The City of Lewes

STAFF REVIEW

June 4, 2019 (updated preliminary consent plan)

Application Title	Fishers Cove
Application Type	Preliminary Consent - Major Subdivision
Owner	Burke & Rutecki, LLC
Tax Map and Parcel	SC Tax Map# 335-4.00-15.00
Size and Location	11.08 acres and located off Rodney Avenue, southwest of Pilottown Road
Comprehensive Plan Designation	Residential
Zoning District	R-2 – Residential Low-Density
Present Use	agriculture/vacant
Proposed Use	18 additional residential dwellings
Online application material	https://lewescommissions.wordpress.com/reviews/dev_reviews/fishers-cove/

TRIP GENERATION - PILOTTOWN ROAD (S-267) AND RODNEY AVENUE

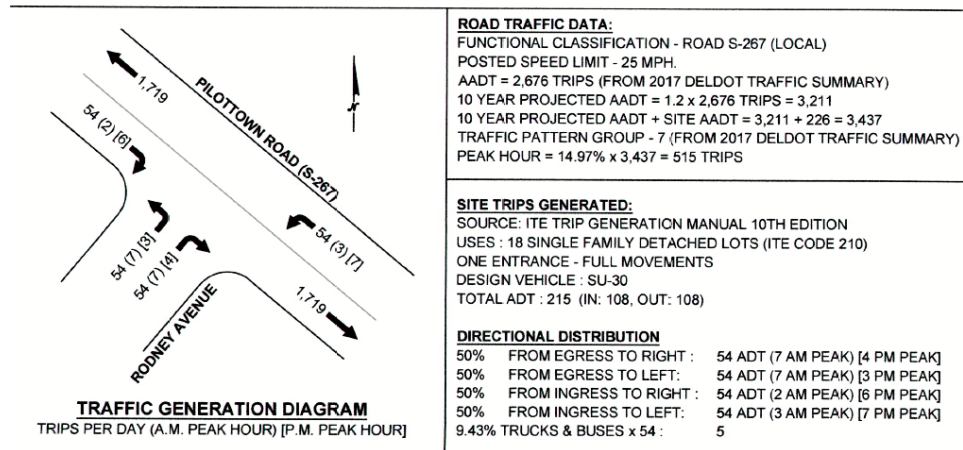
Included within the plan application is a panel that describes traffic generation and distribution. The information indicates that the development would result in an additional 215 average daily trips per day. As suggested in the panel distribution of the current and additional traffic (estimated to be 500 average daily trips), at the intersection of Rodney Avenue with Pilottown Road, would be evenly split (see Trip Generation image below).
